intel® Action Alert

AA-0760-3

June 21, 2005

Intel® Server Chassis SR2400 - Active PCI-X Riser Card Option Heat Sink Falling Off

Figure 2: Active PCI-X Riser Card Heat Sink and Retention Mechanism

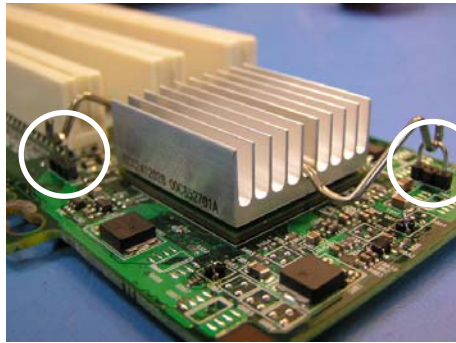
Intel has determined that the solder joints for the U-Anchors used to hold down the heat sink retention clip, may fail over time. Time to failure is highly dependent on system configuration and operating environment. Failure analysis testing has shown that system configurations consisting of several high load add-in cards and/or systems operating in high ambient temperatures may experience a solder joint failure within 2-3 months after deployment. Lesser configurations and/or systems running in lower ambient temperatures may experience a solder failure 9–15 months after deployment.

If a U-anchor failure were to occur, it is possible for the loose heat sink or U-anchor to cause an electrical short on the baseboard causing the server to power off. To date, reported failure data has not indicated any loss of data or specific safety issue related to the system level product.

Intel has identified a new 'J' hooked U-Anchor design. The new U-Anchor design will retain its hold on the board should its solder joints ever fail, preventing the heat sink from falling off.

At the time the issue was discovered, Intel placed all PCI-X Active riser cards on build and ship hold. All finished goods present in its factory and warehouses were reworked to include the new U-anchor design. Reworked boards will have a **PBA# of C53349-204** and a **“Pack Date” of 15 MAR 2005 or later**.

All new riser card assemblies will use the new U-Anchor design. All new riser cards will have a **PBA# of C53349-302** or later and a **“Pack Date” of 15 MAR 2005** or later.
